SAFETY EVALUATION BY THE OFFICE OF NUCLEAR REACTOR REGULATION

SUPPORTING AMENDMENT NO. 41 TO LICENSE NO. DPR-38

OCONEE NUCLEAR STATION, UNITS 1, 2 AND 3

DOCKETS NOS. 50-269, 50-270 AND 50-287

OCONEE NUCLEAR STATION
STATION ORGANIZATION CHART
FIGURE 6.1-1

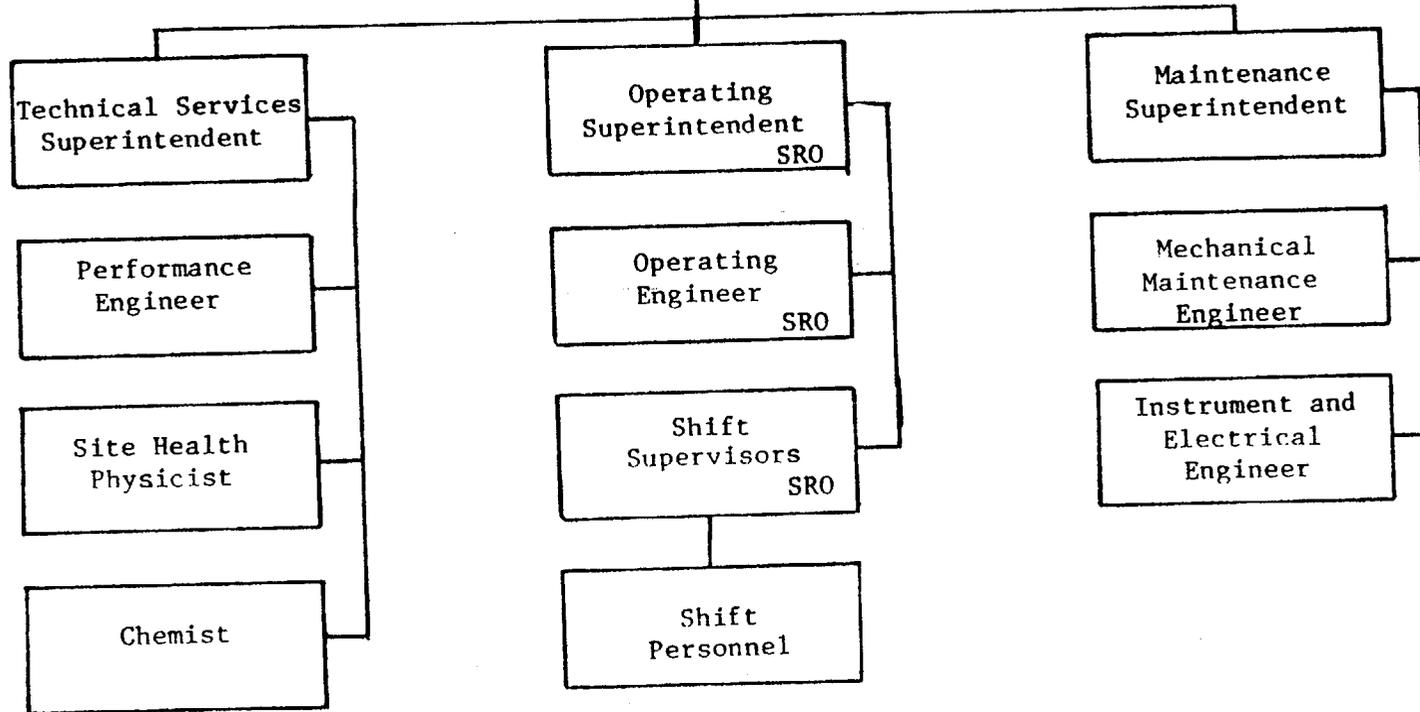
5. Technical Specification 6.6.2.2.c and d would be revised to delete certain reporting requirements when a measured level of radioactivity in any environmental medium exceeds the control station value by a specified amount.
6. Technical Specifications 3.5.2.7, 6.4.1, 6.4.3, 6.5.2, Table 4.11-1, and Figure 6.1-1 would be revised to reflect administrative changes.
